**Overview:** The initial production release of the FTI-TLK1 harness has an issue where in some vehicles the secondary power input to the CN1 connector will overload the associated vehicle circuit, causing a fuse to blow. This issue affects the initial release of harnesses and is already being addressed in production. A field correction procedure is detailed below in Figure 1.

# FTI-TLK1 Type 3C2 - Vehicle Coverage & Preparation Notes

# FTI-TLK1 Type 3C2 - Installation Notes & Wiring Diagram

**Figure 1: Step by step adapter correction**

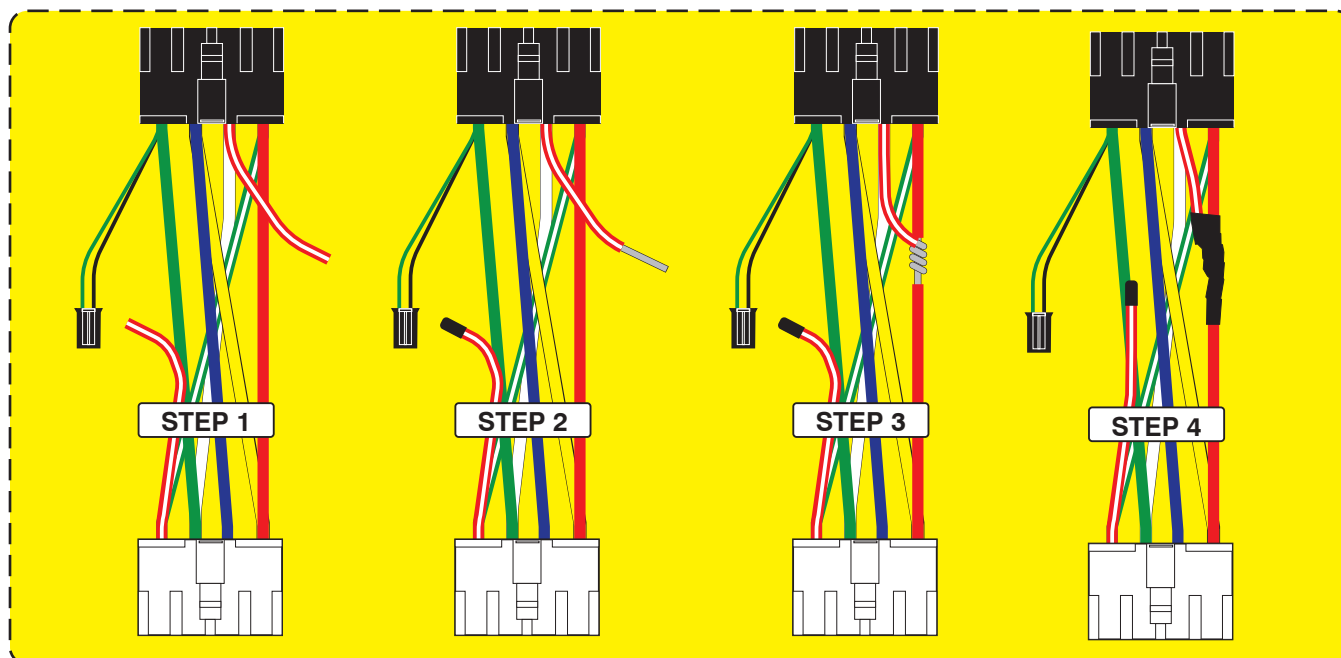
**Issue:** The secondary power circuit can overload some vehicle ignition switch circuits, causing a blown 5A/7.5A AM1 fuse, potentially disabling the vehicle and leaving the consumer stranded. Affected adapters are illustrated below in figure 2.

- 1.) Select the applicable CN1 adapter, isolate the RED/WHITE power wire, cut wire approximately 4" from the BLACK plug
- 2.) Insulate the wire still connected to the WHITE plug using heat shrink tubing, and strip the insulation on the other wire end
- 3.) Strip a portion of the insulation from the RED wire, attach the stripped RED/WHITE to the exposed RED wire, solder together
- 4.) Apply insulating tape to the soldered connection and secure the cut ends back to the bundle of wires created by the adapter
- 5.) Correction complete, you may safely proceed to finish your installation

**Figure 2: Supplied CN1 Harness Adapters**

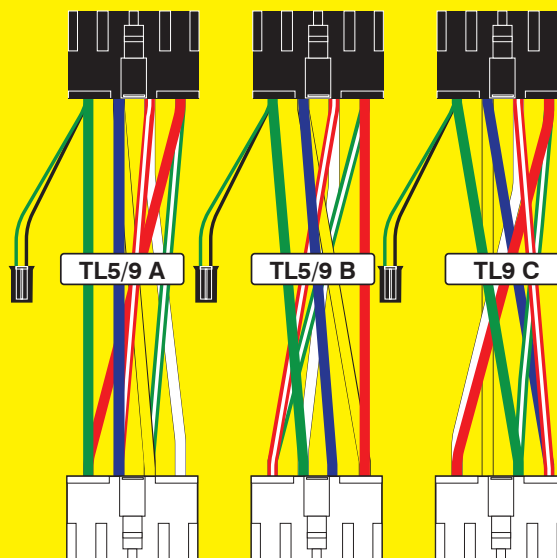
**Incorrect power provisions with the potential to overload vehicle ignition supply circuit, resulting in blown AM1 fuse.**
